NDT Incident

Incident details

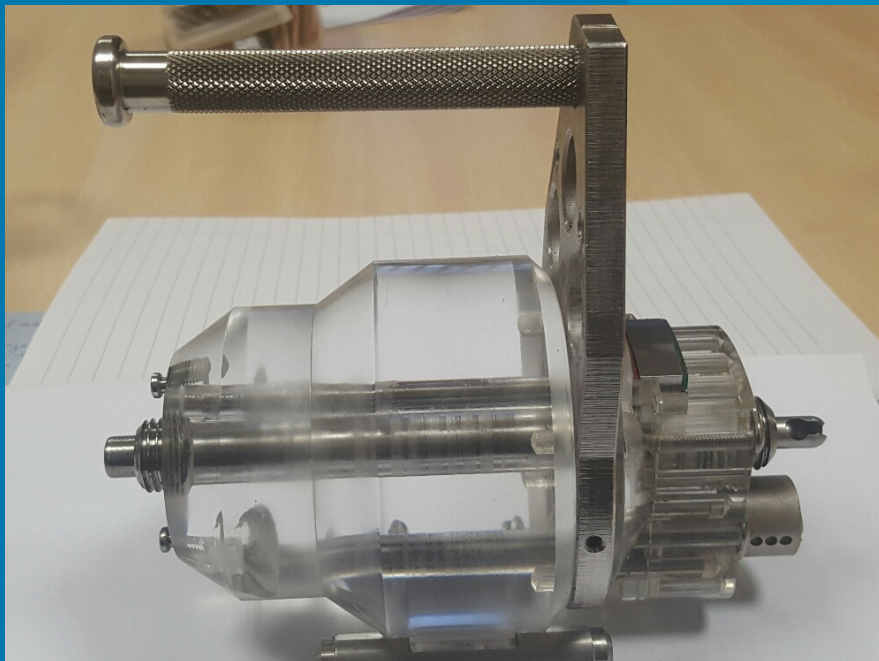
SAFE TO APPROCH

GREEN CLOSED position indicates that Source holder is inside Container and **LOCKED** in Position

UNSAFE TO APPROCH

RED OPEN position indicates that the Source holder is **NOT LOCKED** inside the Container

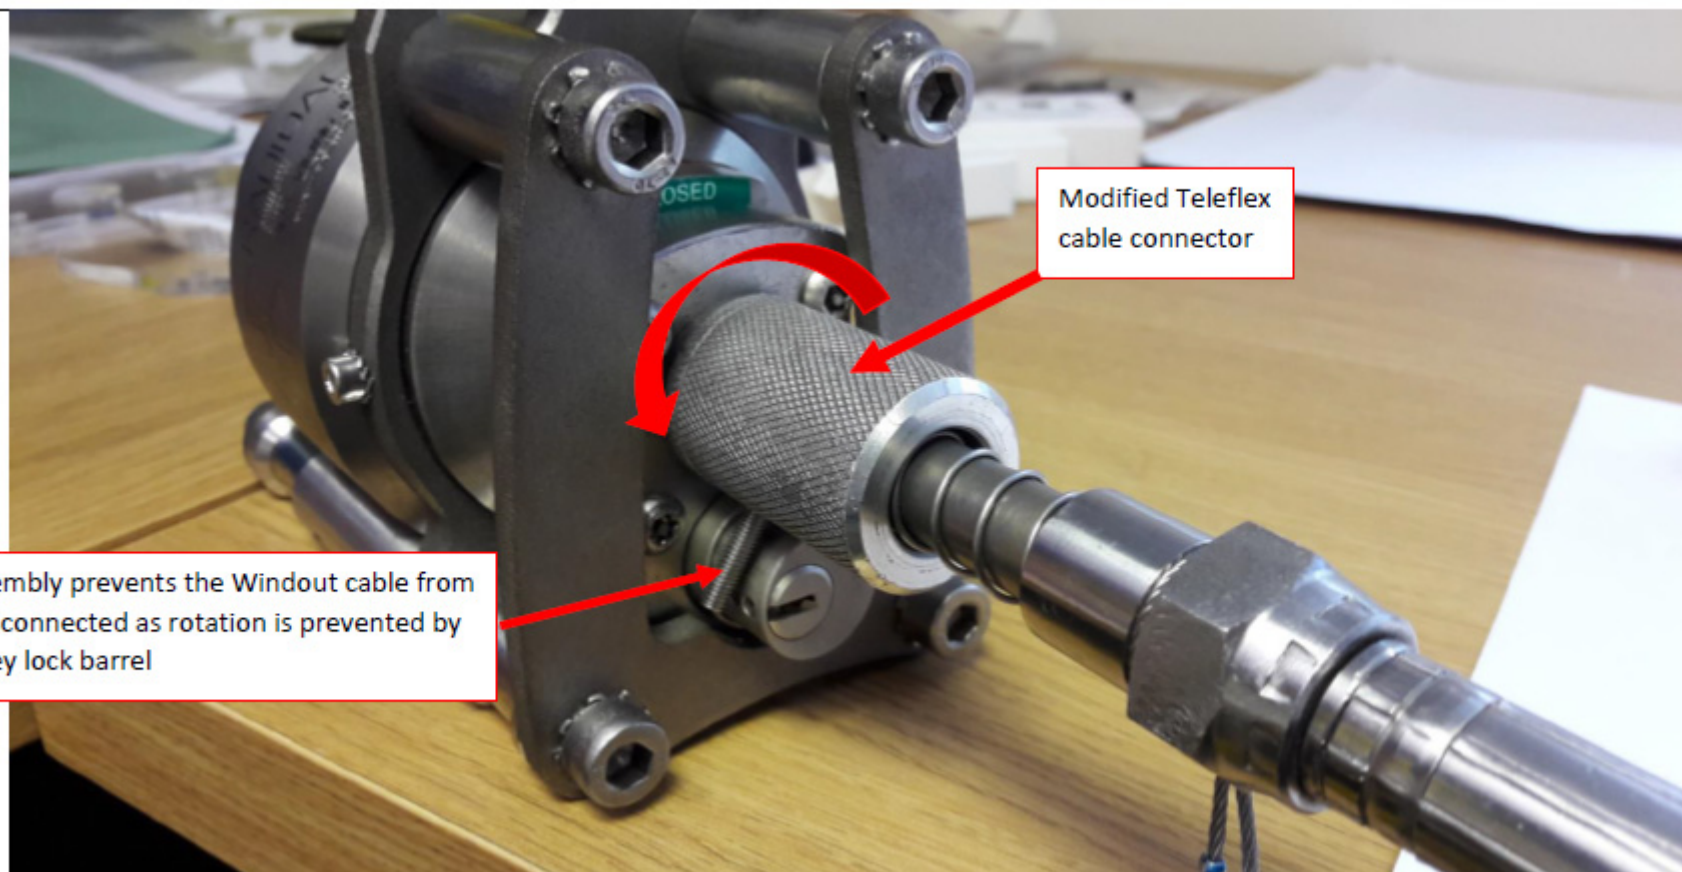
- Training of operators in the specific use of the Projector and in source recovery procedures for reasonably foreseeable accident or incidents during routine use both by the licensed user and/or the manufacturer needs to be improved.
- The Operators Manual would benefit greatly from clear bulleted instructions or steps for disconnection including photographs of the process and the inclusion of a list of reasonably foreseeable accidents/incidents that can occur during routine operation together with the Manufacturers guidance on how to deal with them.
- It was relatively easy for the operator to overcome the manufacturer's engineered solution designed to prevent the wind-out drive cable from separating from the pig-tail with the Projector indicating RED.

- NDT Licence conditions are to be upgraded to include a condition for mandatory operator training in the specific use of the licensed Projector and in source recovery procedures for reasonably foreseeable accident or incidents during routine use.
- Operators Manual is to be upgraded to include clear bulleted instructions or steps for the connection and disconnection of the accessories including photographs of the process and to include a list of reasonably foreseeable accidents/incidents that can occur during routine operation together with the Manufacturers guidance on how to deal with them.
